**BULGA OPTIMISATION
PROJECT MODIFICATION 3
AND BULGA UNDERGROUND
MODIFICATION 7**

Submissions Report

December 2019

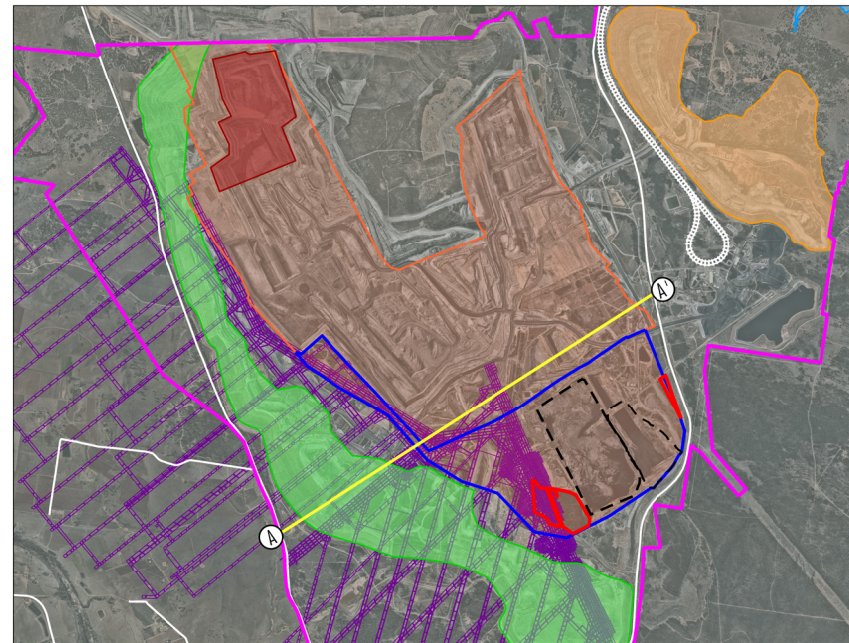
The Department notes that the proposal seeks to extract deeper coal seams down to the Bayswater seam, however the maximum extraction depth of 400 metres below ground level is only mentioned in the Appendix 5, and not clearly discussed in the SEE. Please provide further clarity on the proposed maximum extraction depth.

Cross-sections of the open cut pit are presented in Figure 3.6 of the SEE which demonstrate the proposed deeper mining within the approved open cut pit and proposed extension.

SSD 4960 Modification 3 aims to extract an additional coal seam down to the Bayswater seam. The maximum extraction depth will be approximately 400 m below the original topography in the South Pit Area (to approximately RL -320 mAHD).

FIGURE 4.1
Proposed Modification
Cross-section

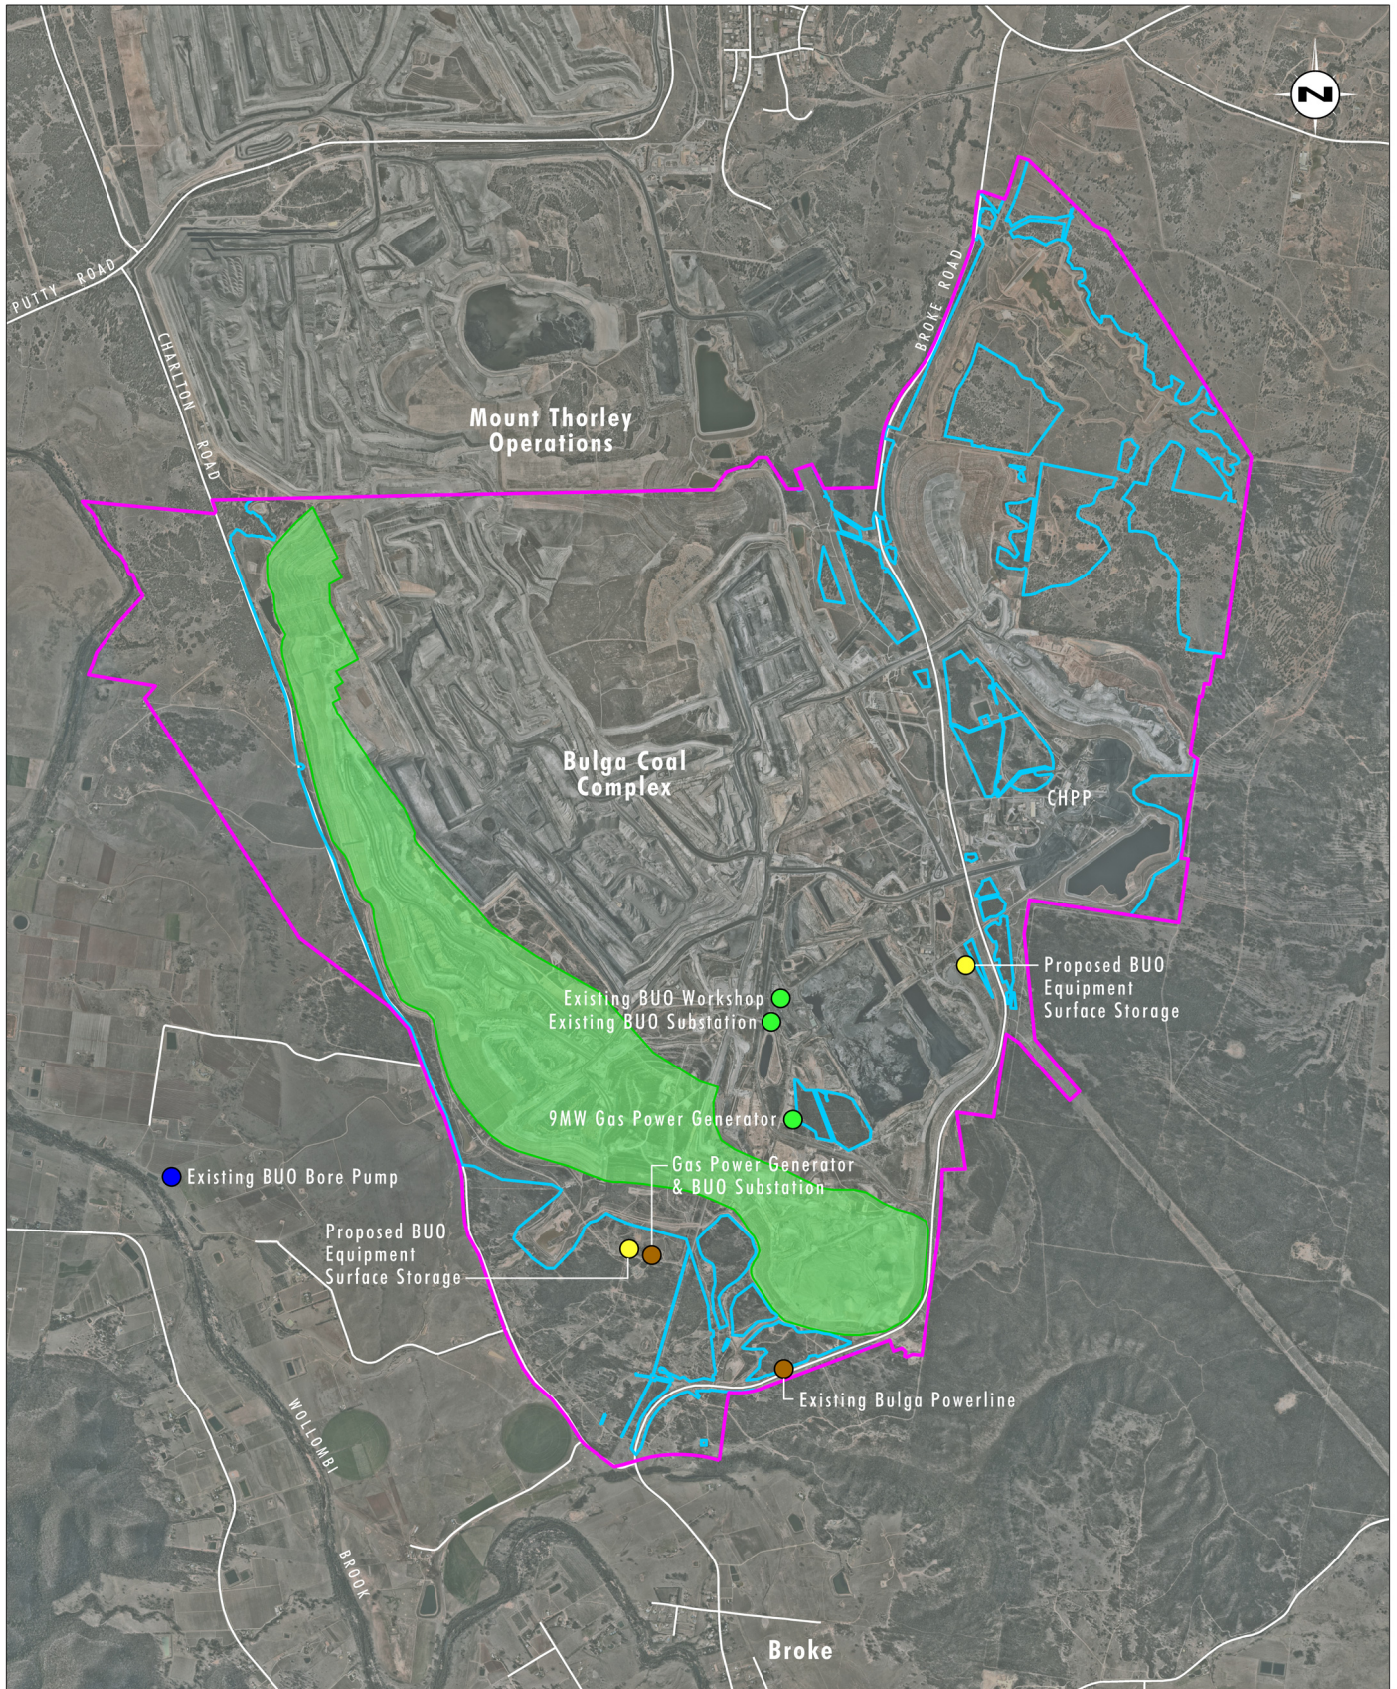
Figure 3.6 provides depth of extraction cross-sections. In addition, the Department requests a figure representing a cross-section of the targeted coal seams and the proposed maximum depth of extraction including any interactions with underground workings and their depths.

Figure 4.1 provides a cross section of the targeted coal seams and the proposed maximum depth of extraction.

Figure 4.3 Predicted Maximum 24-hour average PM_{10} concentrations due to all sources

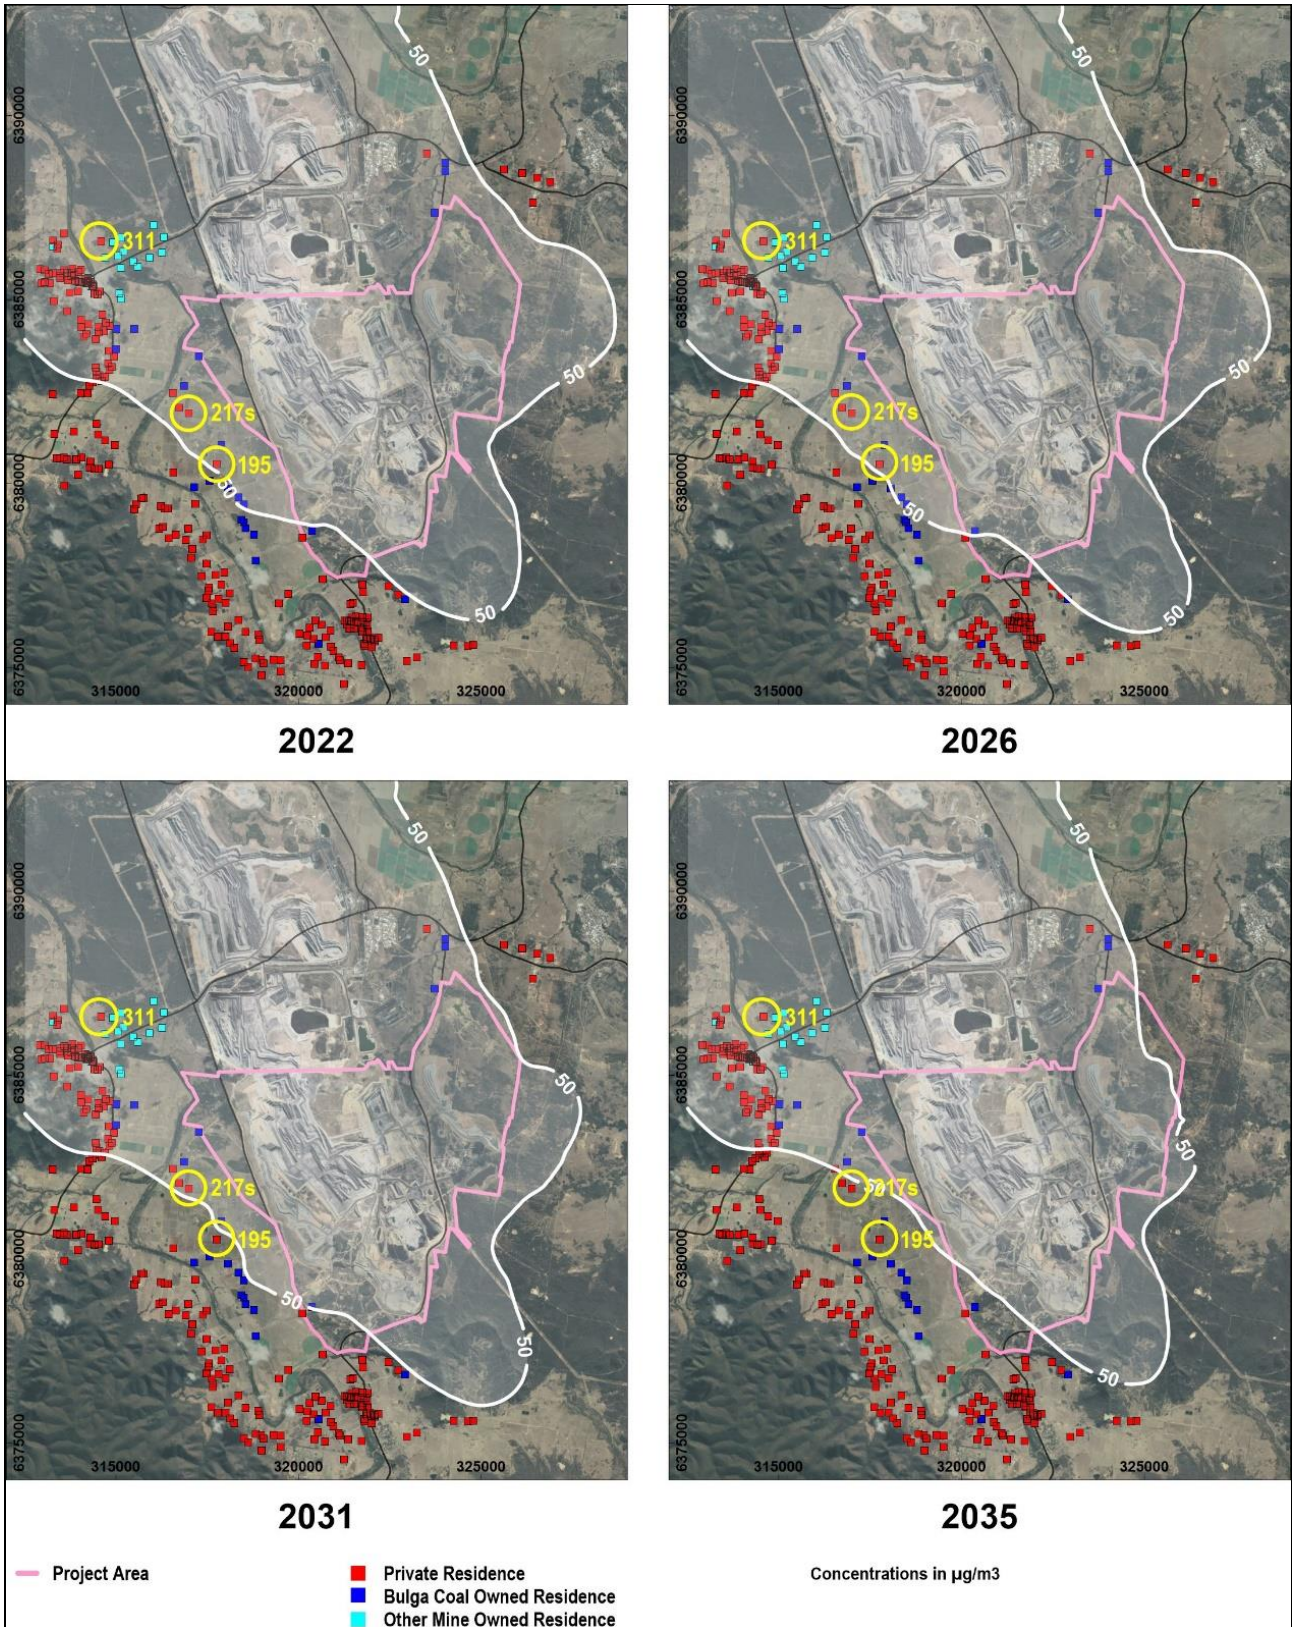
The Proponent must provide justification for the use of Properties 195, 217s and 311 for assessing the 24-hour PM₁₀ impact assessment criteria as well as identifying all properties predicted to experience additional exceedance days as a result of SSD 4960 Mod 3.

The AQIA predicts for the cumulative scenario that numerous private residences will exceed the 24-hour average PM₁₀ criteria of 50 µg/m³ over all years modelled (Figure 19 and Appendix D). The AQIA examines the potential contribution of each source to cumulative concentrations at three locations. Specifically, Property 195 is predicted to experience two exceedance days with a significant project only contribution of 24 µg/m³. Property 311 is also predicted to experience two exceedance days (9 µg/m³) and Property 217s is predicted to experience one exceedance day (6 µg/m³).

Figure 19 of the AQIA showed that maximum 24-hour average PM_{10} concentrations may exceed the EPA's $50 \mu\text{g}/\text{m}^3$ criterion at various private properties, due to contributions from Bulga Surface Operations under SSD 4960 Modification 3, Mt Thorley Warkworth mine and background (other) sources of particulate matter. Three of the closest properties within the extent of predicted impact, in various directions from the BCC, were selected for further, contemporaneous data analysis. Representative properties meeting this criteria were identified as 195, 217s and 311. **Figure 4.3** shows the locations of properties 195, 217s and 311 along with the predicted maximum 24-hour average PM_{10} concentrations due to all sources.

There are no private residences predicted to have additional exceedance days resulting from SSD 4960 Modification 3 in isolation when compared to approved operations (refer to Appendix D of the AQIA).

As discussed in **Appendix 2**, there is no known guidance or standard for defining what constitutes a significant project only contribution. The AQIA has used historical monitoring data to identify existing conditions and used dispersion modelling to forecast the potential future conditions. This process led to the following conclusions:

Maximum 24-hour average PM_{10} concentrations may continue to exceed the EPA's $50 \mu\text{g}/\text{m}^3$ criterion at various locations in the vicinity of the Bulga Coal Complex (including private properties), due to contributions from the Bulga Coal Complex (as modified), Mt Thorley Warkworth mine and background (other) sources of particulate matter. Specifically, the model predictions indicated that there may be up to two days each year when the Bulga Coal Complex (as modified) would contribute to an exceedance of $50 \mu\text{g}/\text{m}^3$ at the nearest locations to the west of the Bulga Coal Complex. These predictions did not highlight any significant change in air quality as they were within the range of historical measured conditions. It is concluded that 24-hour average PM_{10} concentrations will continue to be variable from day-to-day, due to existing conditions and sources, and that operations will need to be managed in a way which minimises the contribution to off-site PM_{10} levels, as is done under the existing approved operation.
